Interactive comment on “Assessing the impact of climate variability and human activity to streamflow variation” by J. Chang et al.

Received and published: 26 August 2015

Fig. 1. Fig. 1. Location of hydrological and meteorological stations in the Jinghe River

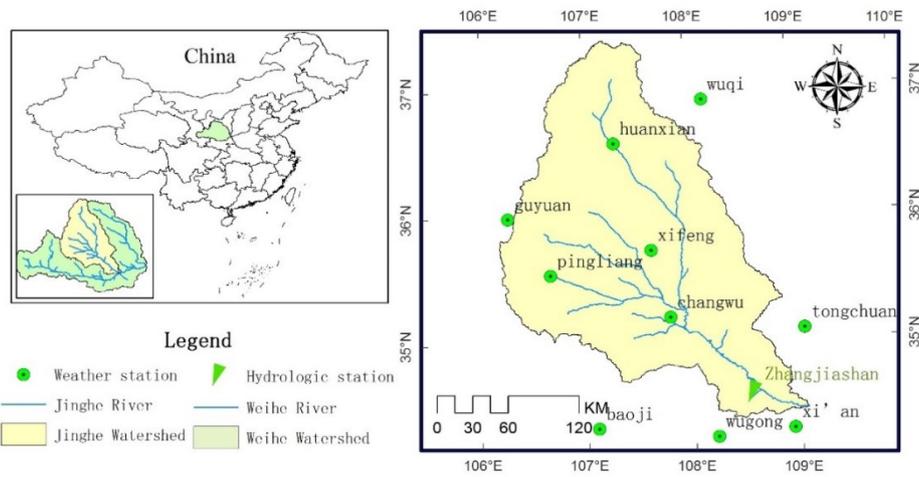
2012.). In this paper, climate variability combined with human activities has contributed to the decrease of the streamflow in the Zhangjiashan hydrological station of JRB. (13) Lines 25-26: Please reword this sentence. Response: We have revised the section about data. In this paper, catchment information data set, including catchment boundary and runoff ratio, was from the Ministry of Water Resources (MWR) of the People's Republic of China. Daily, monthly, and annual climate variables and observed runoff were used. Daily meteorological data of ten stations during 1960–2010, including precipitation, air temperature, sunshine hours, relative humidity, and wind speed, were collected from China Meteorological Administration (CMA). The monthly and annual precipitation, and monthly and annual maximum, minimum, and mean air temperature values were then calculated according to the daily data. The monthly potential evaporation was calculated according to the monthly wind speed, sunshine hours, relative humidity and air temperature by using the Penman-Monteith method. The daily streamflow data of Zhangjiashan hydrological station for the same period were gathered from the Shaanxi Hydrometric and Water Resource Bureau. The DEM data were obtained from the SRTM 40 m Digital Elevation Data. The soil data were extracted from the FAO two-layer 5-min 16-category global soil texture maps. Figure 1 shows the location of the meteorological stations and hydrological station in the basin. (14) Page 5, Line 1: Please check “196-2010”. Response: Thanks for the comment. We have changed the word “196-2010” to “1960-2010” in the revised manuscript. (15) Lines 5-6: Please reword this sentence. It is difficult to understand. Response: We have changed the sentence into “The monthly and annual air temperature values (maximum, minimum, and mean) were then calculated according to the daily data.” in the revised manuscript. (16) Line 13: It is better to merge Figure 1 and Figure 2, since they give the similar information. Response: We have merged Figure 1 and Figure 2 in the revised manuscript.

Fig. 2. Fig.2. The abrupt change points of precipitation and runoff in JRB with Sequential cluster

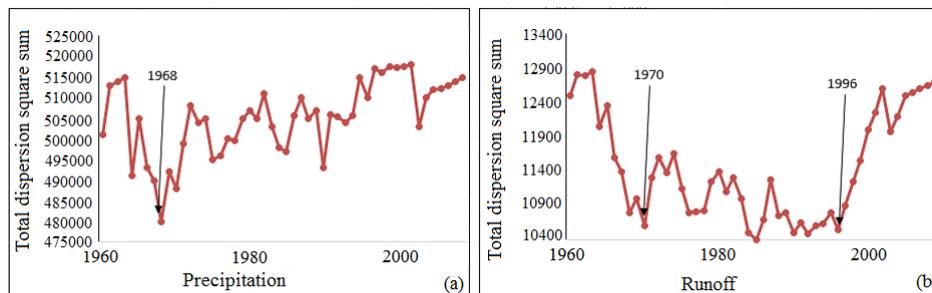
of the precipitation and runoff were not comparable. (28) Lines 24-26: It is ambiguous for this sentence. What's the meaning of "reduced by 17.39 % compared with the multi-year average streamflow"? How the value of 17.39% was calculated? The same issue for the value of -26.96% in next sentence. I suggest the authors to reword this paragraph, because it is hard to understand. Response: We feel very sorry to have brought the trouble to the reviewer. We have checked the results and corrected the sentence. The multi-year average streamflow (from 1960 to 2010) was 37.03mm, and the average value was 43.47mm from 1960 to 1990, which means the streamflow from 1960 to 1990 increased by 17.39% ($((43.47-37.03))/37.03*100\%$) compared with the multi-year average value. The average annual streamflow was 27.05mm during 1991-2010, reduced by 26.96% ($((27.05-37.03))/37.03*100\%$) compared with the multi-year average value, therefore, the speed of streamflow decrease was higher since 1990. (29) Page 11 Lines 22-23: Please distinguish evaporation and potential evaporation. The terms of 60s, 80s should be written as 1960s, 1980s. Please check this kind of issues. Response: Since the data of monthly potential evaporation was calculated by Penman-Monteith method, we have changed "evaporation" to "potential evaporation". We have checked this issue (the terms of 60s, 80s et al.), and changed the wording in the revised manuscript. (30) Page 12 The first paragraph should be put into the section of methods. Response: According to the comment, we have put this section into "3.3 Modeling-Based Approach for ΔQC or ΔQH " in the revised manuscript. (31) Page 13 Lines 14-15: Why did the authors select the period of 1960-1970 as the baseline period? Response: By means of sequential cluster analysis method, we have obtained the break points of precipitation and streamflow in Jinghe River. The break points appeared in 1970s, so we selected the period of 1960-1970 as the baseline period. We have put the investigation results into the manuscript. The break points of precipitation and streamflow are as follows:

Fig.2 The abrupt change points of precipitation and runoff in JRB with Sequential cluster (32) Page 15 Section 4.5: This section should be put before the results of the hydrological models to agree with the presentation of the methods. In section 3, the

Fig. 5. Fig.5. (a) Elevation maps of the study area at 40 m resolution. (b) Grid of VIC model. (c) Sub-basin of TOPMODEL

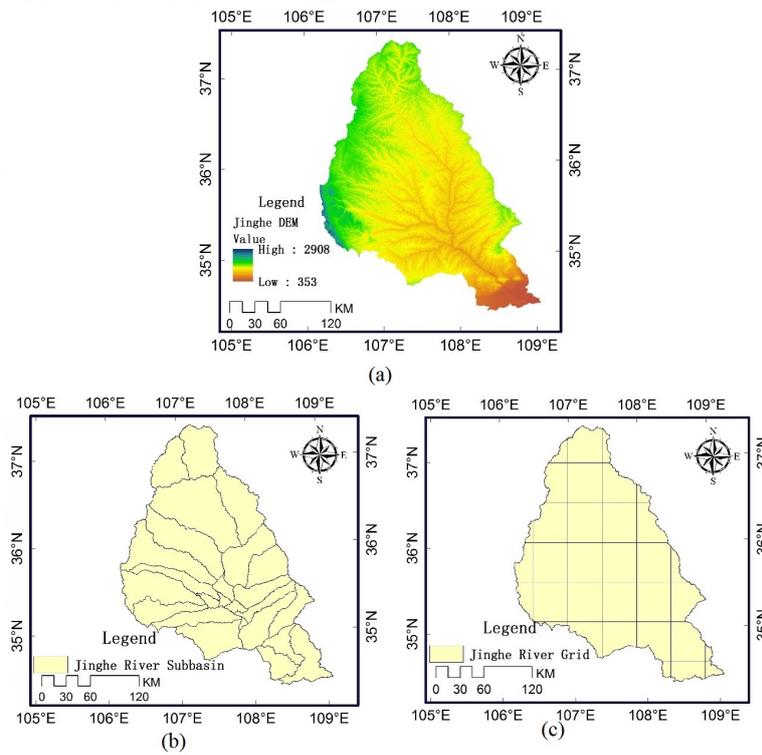
(40) Figures: Please adjust the font sizes in all figures. The font sizes in Figures. 5-9 are too small. It harms the quality of presentation. Response: Corrected.
